REVISED SITE PLAN

RZ-2017-004

RZ-2017-005

Revised "Exhibit A" (August 23, 2017)

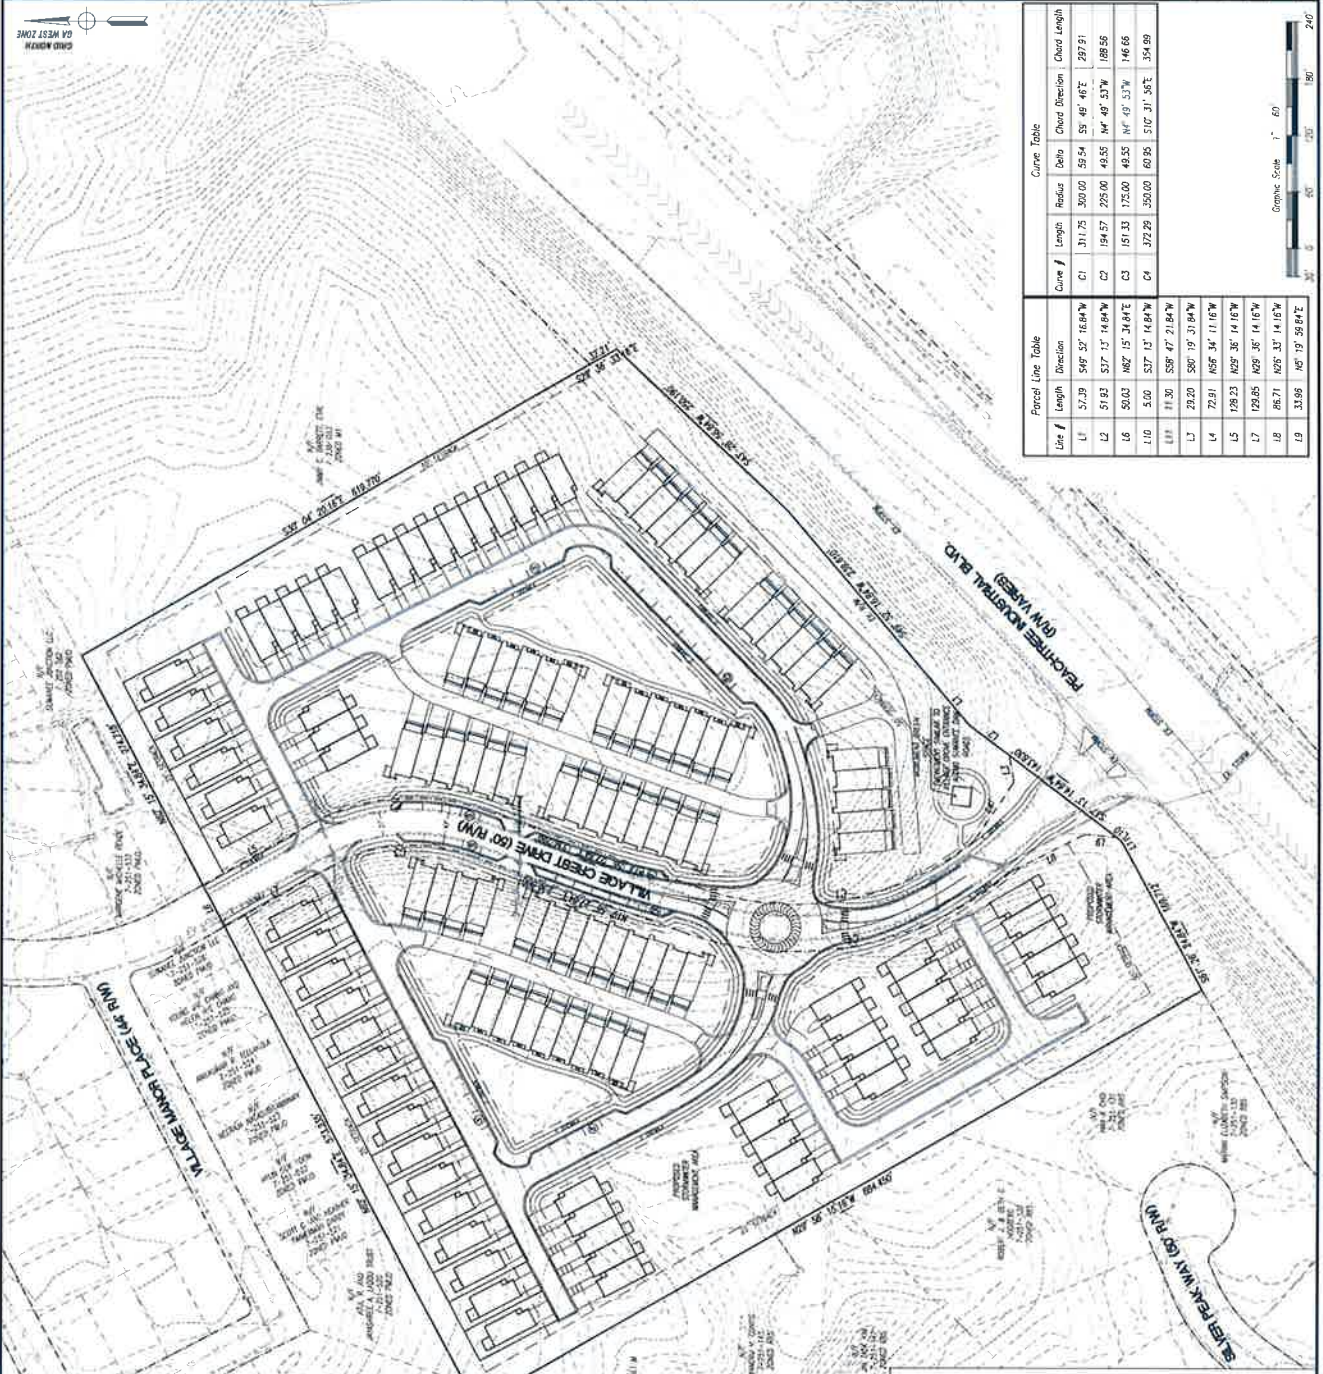
1. Develop in accordance with the concept plan (dated ~~June 29, 2017~~ **August 23, 2017**) and associated attachments and exhibits approved by City of Suwanee, and incorporated herein by reference, with changes as necessary to meet conditions of zoning or other development requirements. This shall include all proposed densities, roadways, land uses, planting, sidewalks, multi-use paths, detention areas, or other proposed features shown on the submitted plan. If needed due to conditions of zoning that require substantial changes to the concept plan, submit revised plans to the City that reflect the changes required herein by the conditions of zoning.

2. Use shall be limited to a maximum of ~~75~~ **62** attached or detached single family homes. **The total number of single family attached units shall not exceed 47.** However, the total number of units permitted by RZ-2017-004 and RZ-2017-005 shall not exceed ~~146~~ **131** units.

3. All units ~~adjacent~~ **-facing** to Village Crest Drive shall ~~face Village Crest Drive and~~ have rear-loaded garages.
4. A minimum of ~~50% of all~~ **22** units shall be served by rear-loaded garages. All units with rear-loaded garages shall access those garages via rear alleys.
